Management Summary and Reporting Memo

on Verification Observations on Landis+Gyr Testing Report

Author: Reliability Core Team Holland Innovative Sept-Oct 2017	Client / contact: Bert van Creij Liander Sept-Oct 2017
--	--

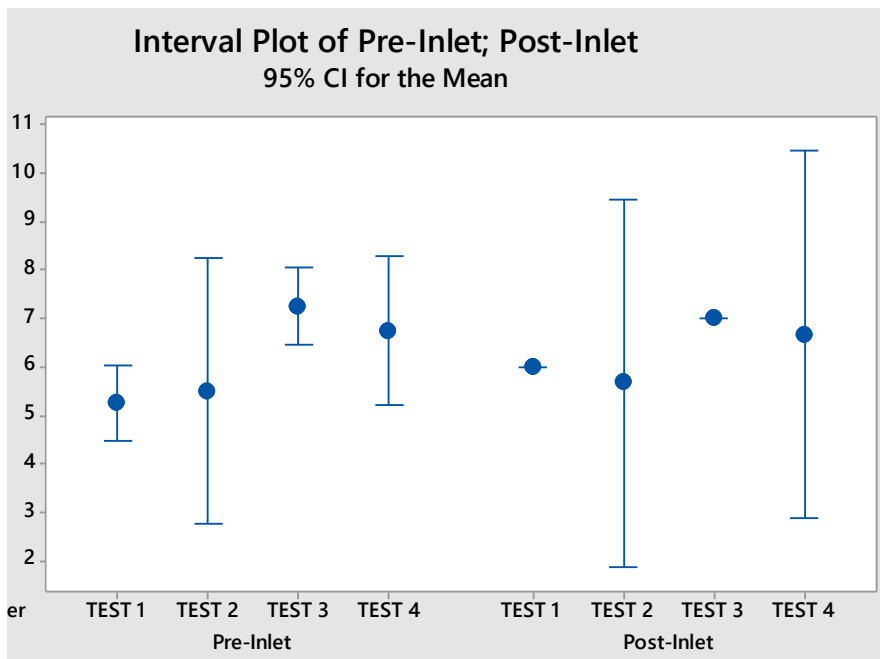
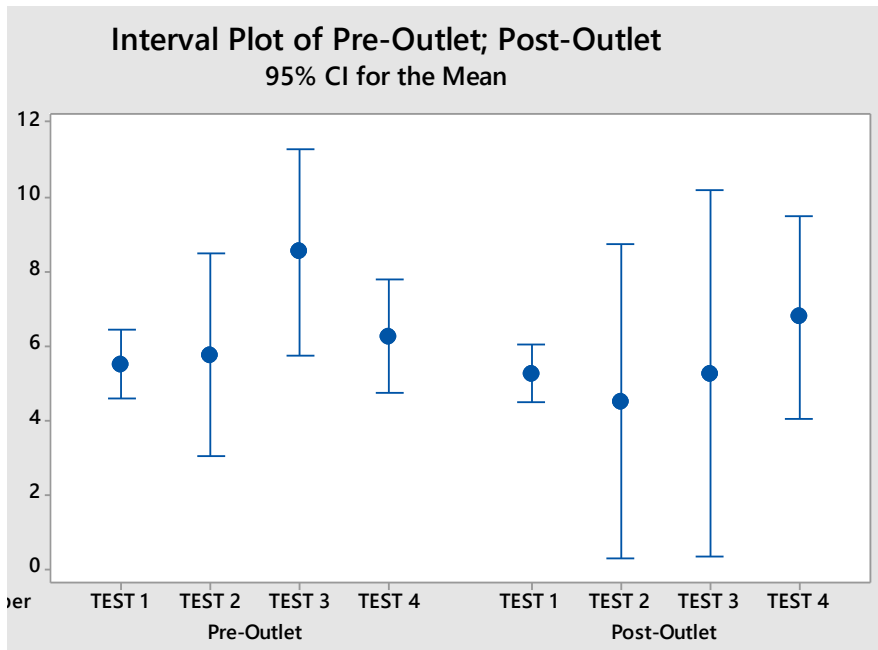
The statement that the tightening torque increased as the test progresses cannot be statistically proven, see graphs (next page) with the measured torques (shown in Landis+Gyr table) – no trends upwards or downwards can be observed. The measurement system has not been analyzed by Landis+Gyr with respect to systematic and random error, and the measured torques are depicted as integer (no decimals). In addition, Two-sample T-tests show no significant difference 'over time' between the measured torques throughout the tests progressing. Also, regression lines did not show significant correlation between test progression and measured torques ($R\text{-sq} < 20\%$).
